DATE: 15 February 2016 ADDRESS: 35 Racine Ave. (Lot # 43) CBL: 399-C-043

REASON FOR PERMIT: New Single Family with garage under (raised ranch)

CITY OF PORTLAND, ME  
BOCA 1996 Plan Review Record  
One and Two Family Dwelling

**SINGLE FAMILY RESIDENCE PLOT PLAN**  
 OF:  
**LOT 4 RACINE AVENUE**  
 RACINE AVENUE  
 PORTLAND, MAINE  
 FOR:  
**MICHAEL NAPPI**  
 10 MORNING STREET  
 PORTLAND, ME 04101

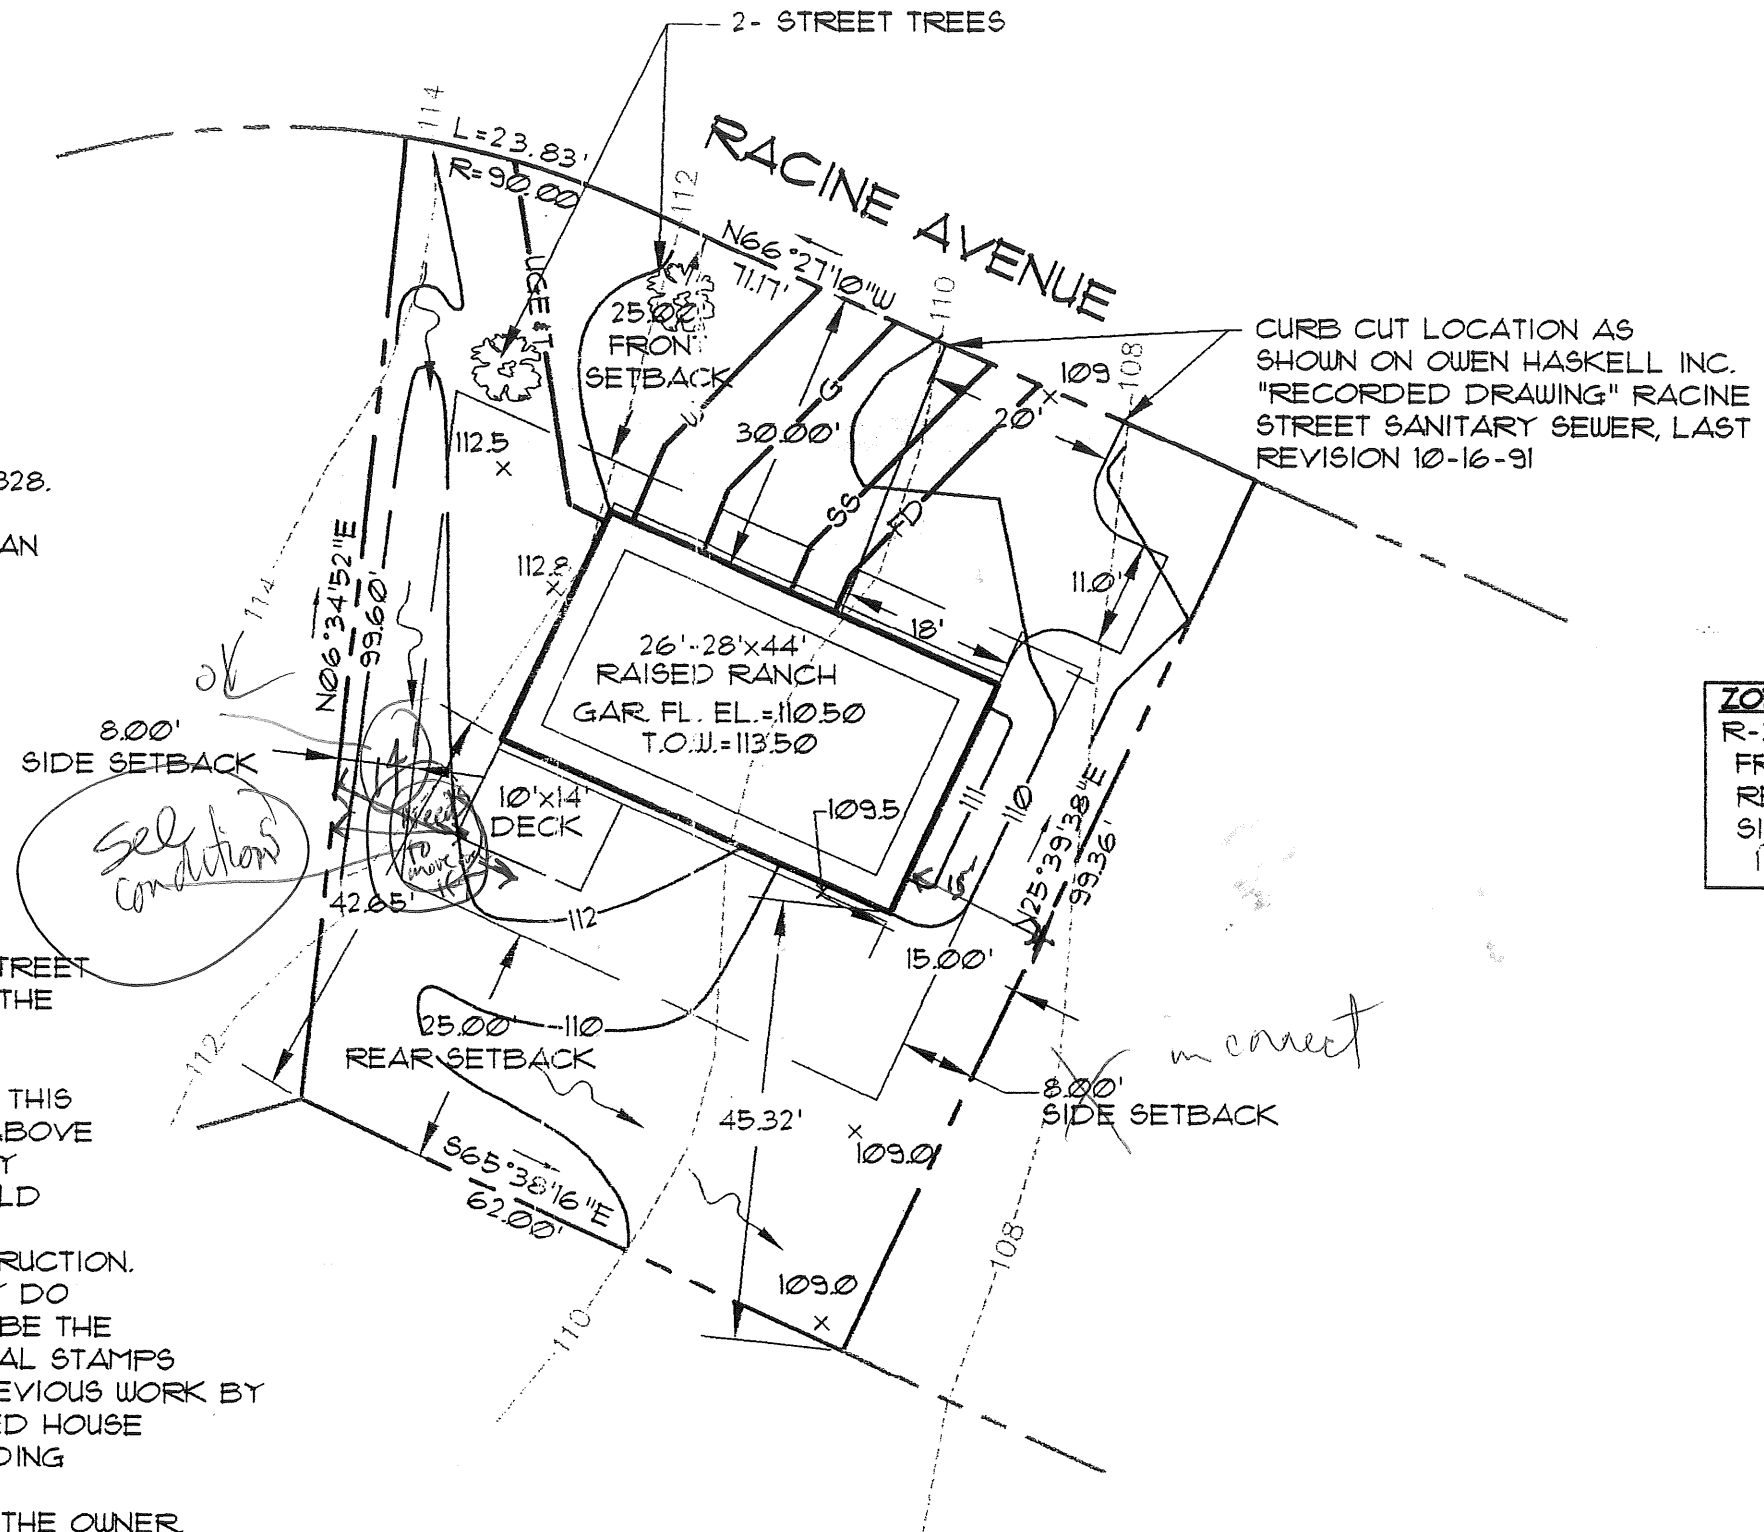
3/22/00 Call for Foundation prep - lot line not clearly laid out  
pin not visible - Right rear corner of deck appears to be into  
setback

3-23-00 Setbacks - OK w/ JonK - front retaining wall not on plans - not being  
poured - only box of house <sup>in</sup>
